UNITED STATES PATENT AND TRADEMARK OFFICE

APPLICATION NO.	FILING DATE	FIRST NAMED INVENTOR	ATTORNEY DOCKET NO.	CONFIRMATION NO.
10/520,428	01/06/2005	Klause Lenhart	2502 0171US	9910

Office Action Summary

DETAILED ACTION

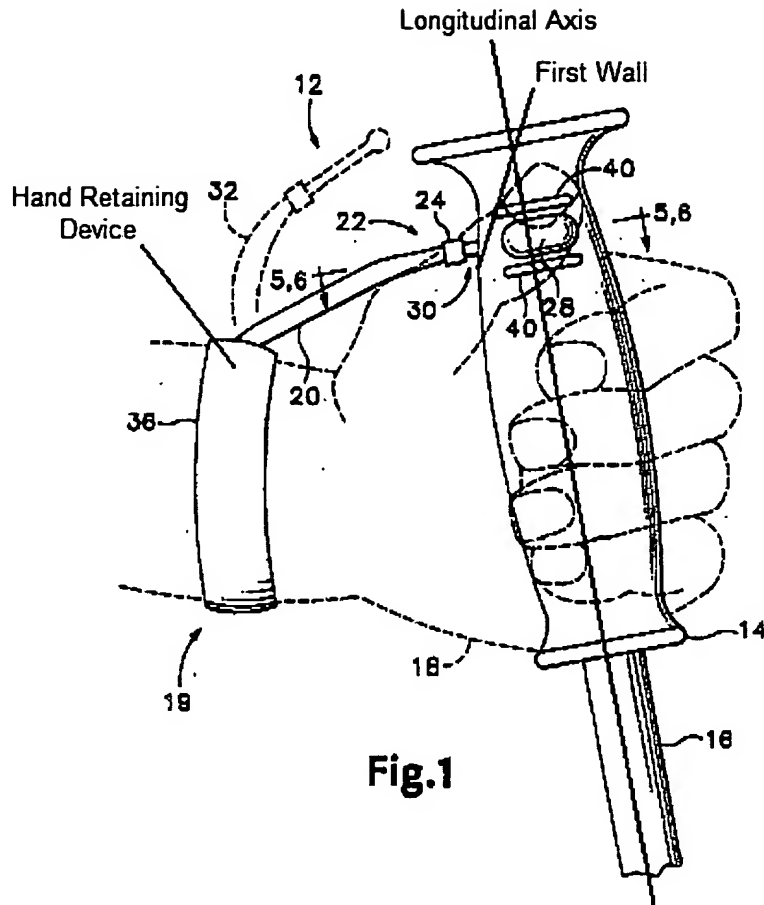
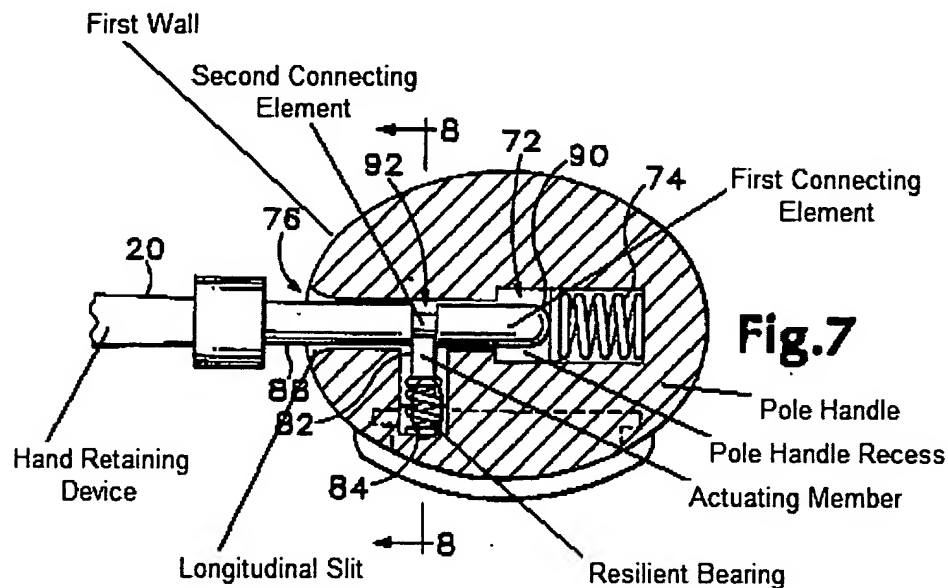
- A hand retaining device (Figure 1)
- A first connecting element integral with the hand retaining device (Figure 7)
- First connecting element for detachably locking the hand retaining device to the pole handle (Figure 7)
- Means defining a pole handle recess (Figure 7)
- Recess defining means having a first wall facing the hand retaining device (Figures 1 and 7)
- The first wall having a longitudinal slit providing access to said pole handle recess for insertion and removal of the first connecting element (Figures 1 and 7)
- The longitudinal slit extending parallel to or at an angle with respect to a longitudinal pole axis (Figure 1)

- A second connecting element disposed in said pole handle recess to cooperate with said first connecting element (Figure 7)
- An actuating member communicating with the second connecting element (Figure 7)
- The actuating member structured and dimensioned for access in a region of a pole handle head (Figure 7)
- A resilient bearing cooperating with the actuating member to oppose the second connecting element motion caused by the actuating member (Figure 7)

- The longitudinal slit extends from above to below a range of motion of the second connecting element (Figure 7)

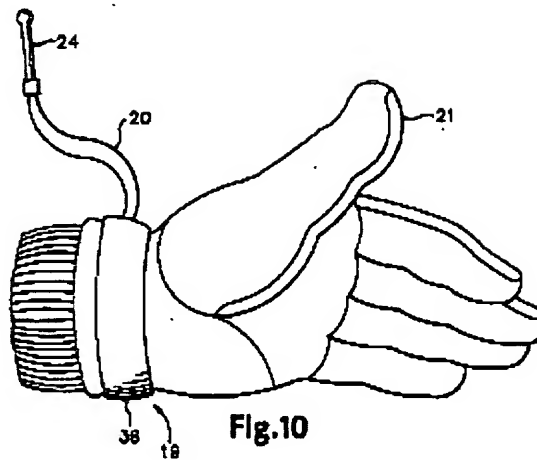
- Hand retaining device comprises a toggle strap or a glove (Figure 10). Discloses a glove being attached to the pole strap.

Fig.2

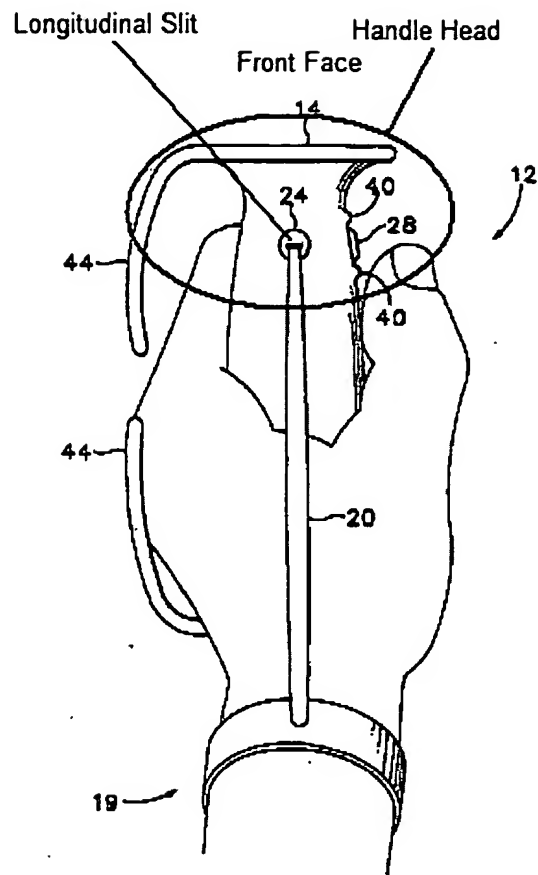
- The longitudinal slit can be accessed in a region of a handle head front face
(Figure 2)

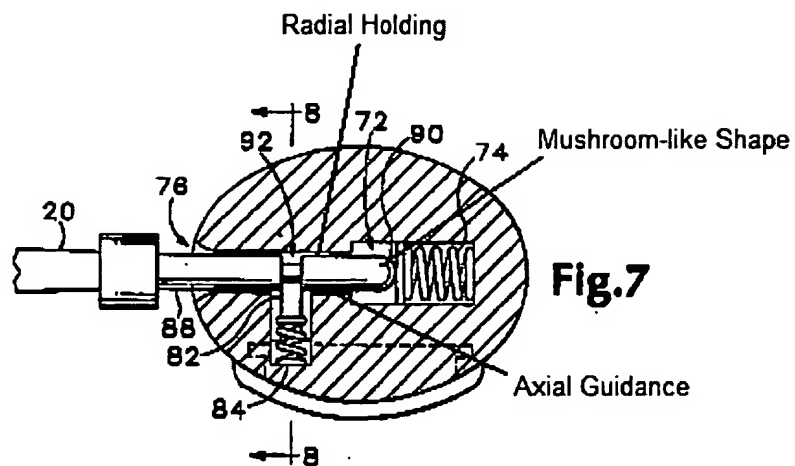
- First connecting element comprises a mushroom-like or other undercut shape for axial guidance and radial holding in the longitudinal slit (Figure 7)

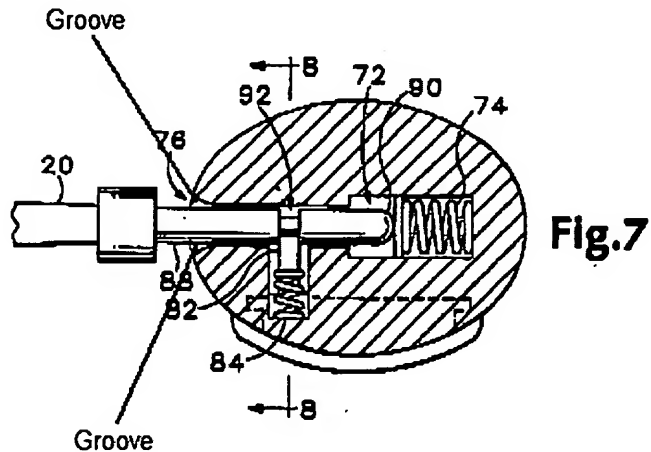
- The first wall has opposite grooves which guide the first connecting element (Figure 7)

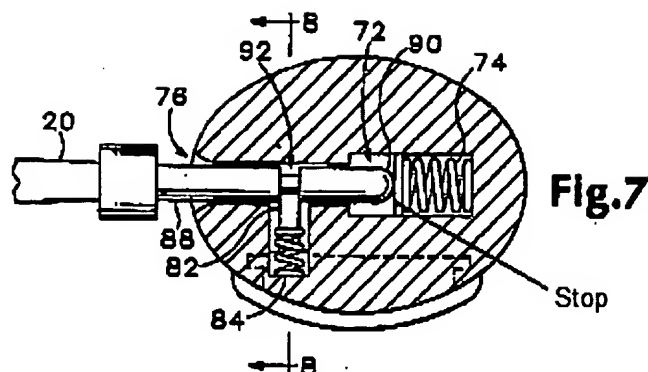
- An end of the longitudinal slit defines a stop for the first connecting element during insertion into the pole handle recess (Figure 7)

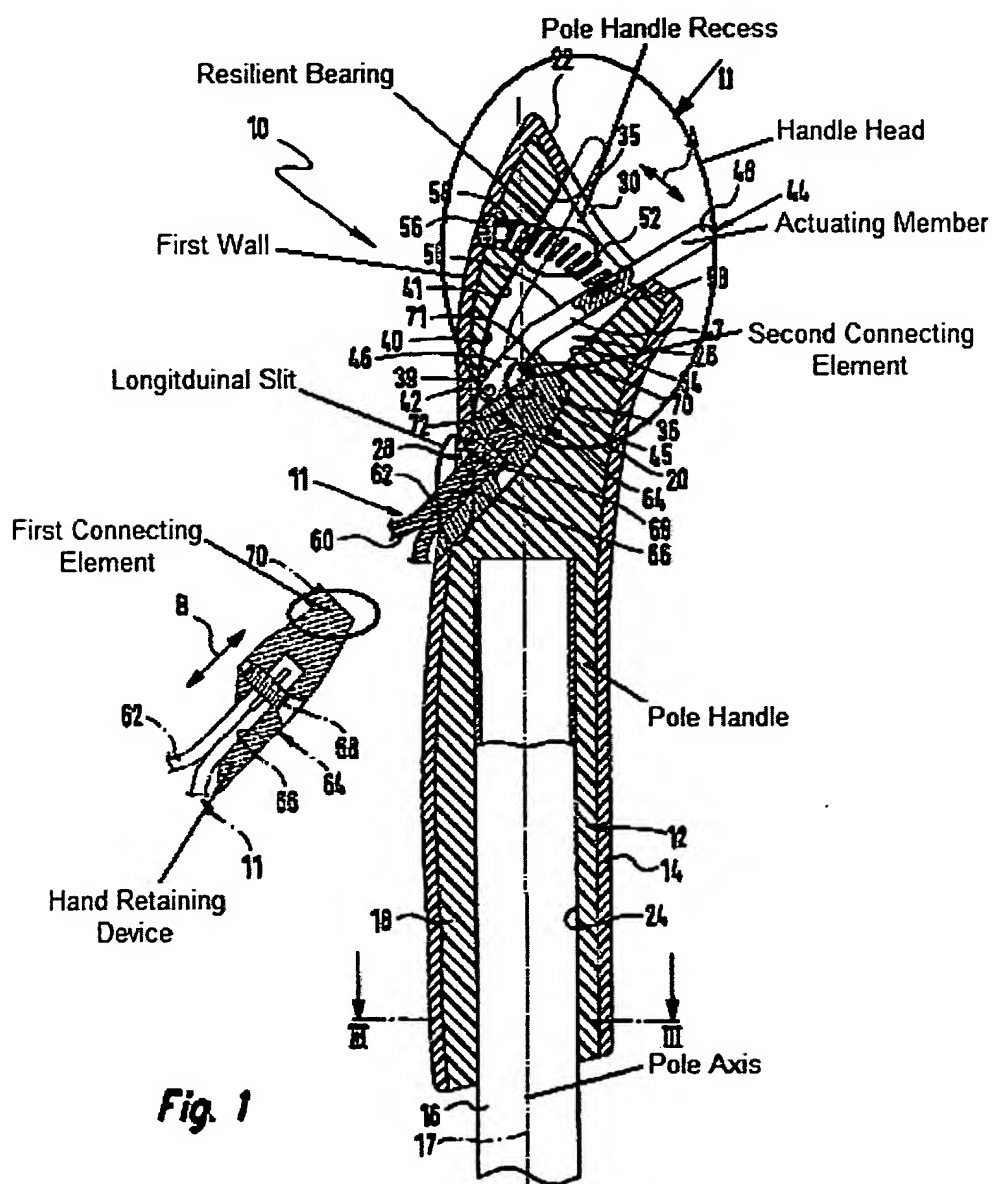
- A hand retaining device (Figure 1)
- A first connecting element integral with the hand retaining device (Figure 1)
- First connecting element for detachably locking the hand retaining device to the pole handle (Figure 1)

- Means defining a pole handle recess (Figure 1)
- Recess defining means having a first wall facing the hand retaining device (Figure 1)
- The first wall having a longitudinal slit providing access to said pole handle recess for insertion and removal of the first connecting element (Figure 1)

- The longitudinal slit extending parallel to or at an angle with respect to a longitudinal pole axis (Figure 1)
- A second connecting element disposed in said pole handle recess to cooperate with said first connecting element (Figure 1)

- An actuating member communicating with the second connecting element (Figure 1)
- The actuating member structured and dimensioned for access in a region of a pole handle head (Figure 1)

- A resilient bearing cooperating with the actuating member to oppose the second connecting element motion caused by the actuating member (Figure 1)

- The longitudinal slit extends from above to below a range of motion of the second connecting element (Figure 1). It would be obvious to one of ordinary skill in the art to rearrange parts as to allow for the longitudinal slit to be above and below a range of motion of the second connecting element so as to allow for a larger and more substantial hand retaining device to be inserted into the longitudinal slit.

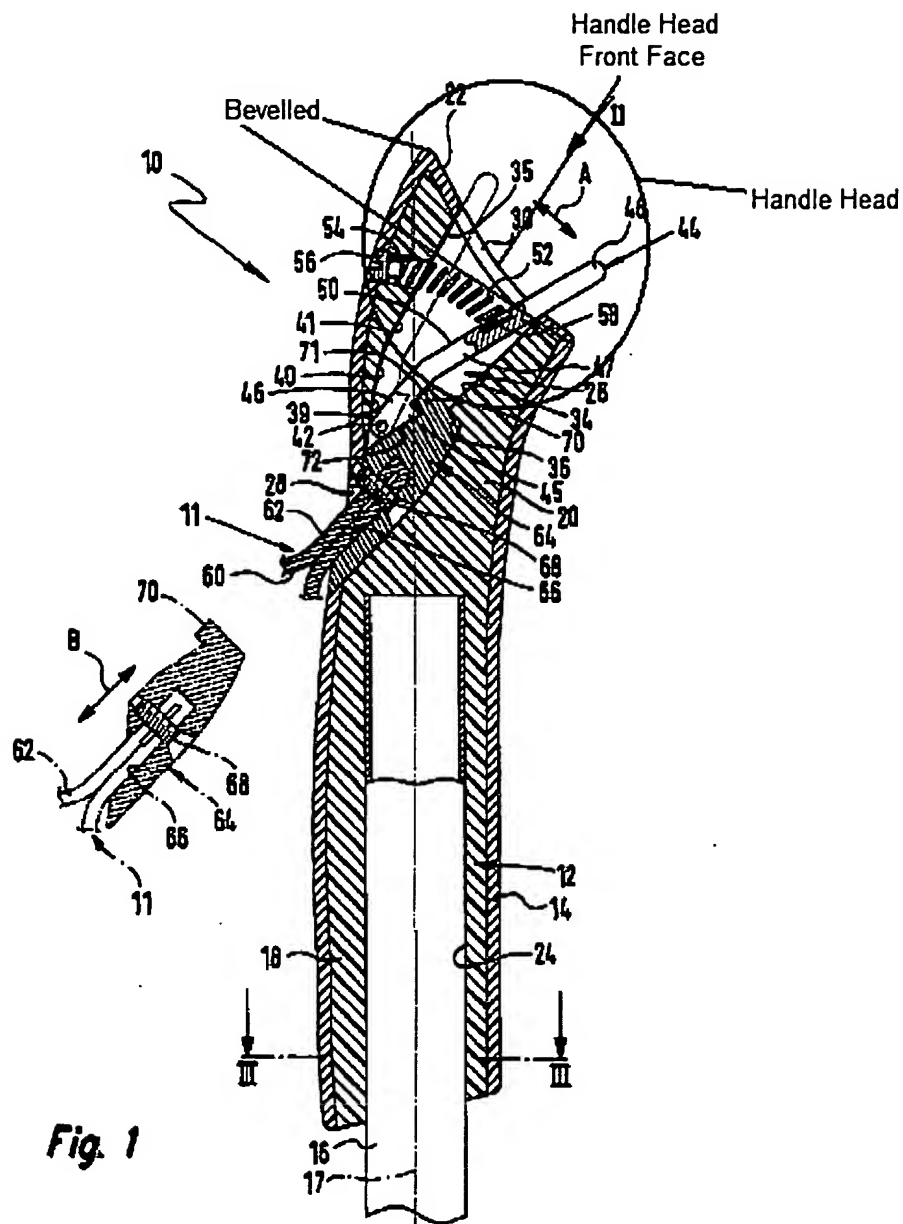
- A handle head front face of the pole handle defines a longitudinal opening through which the actuating member projects (Figure 1)

- The front face is beveled (Figure 1)

- Actuating member comprises a first lever which is pivotally disposed in the pole handle recess (Figure 1)

- The first lever is integral with the second connecting element to define a two-armed lever (Figure 1)

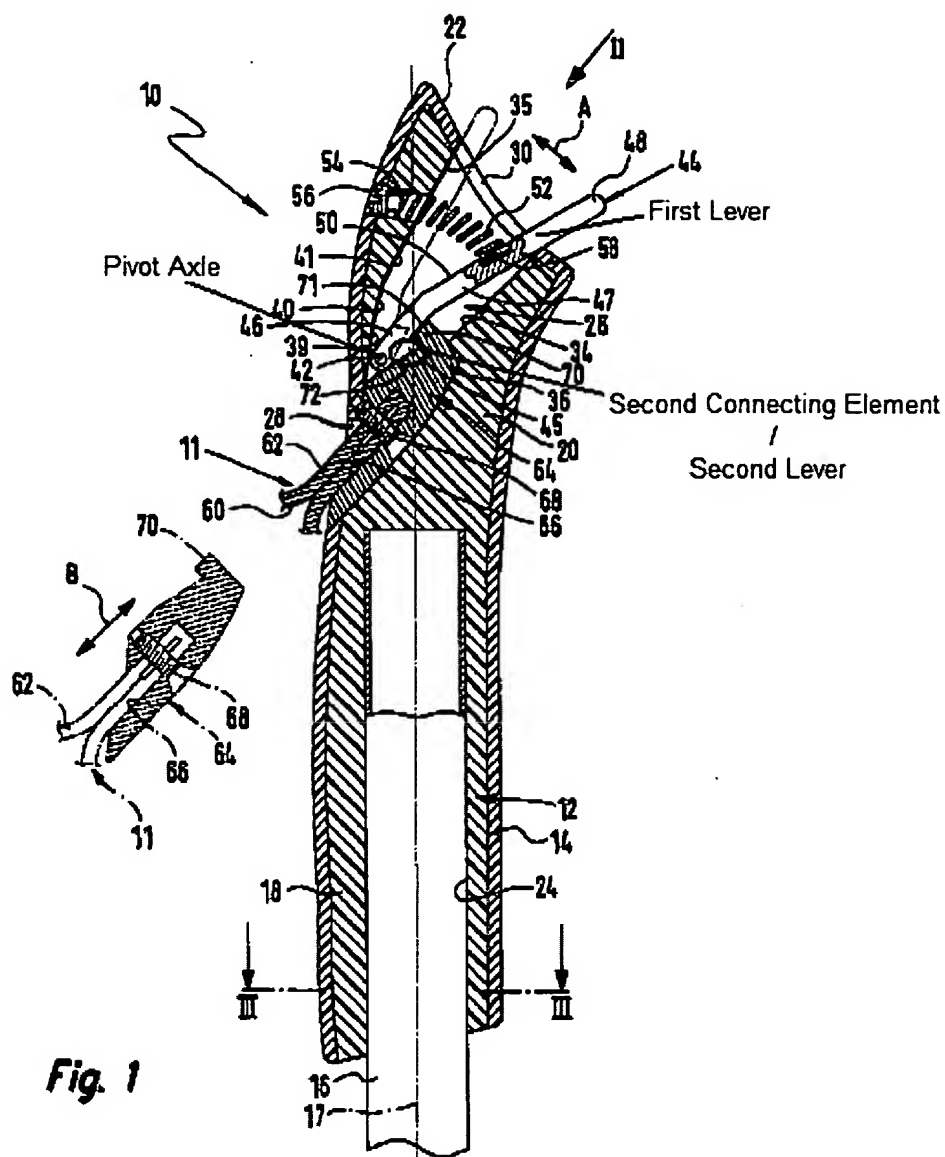
- The two-armed lever is hinged to a pivot axle which is disposed proximate to the first lever (Figure 1)
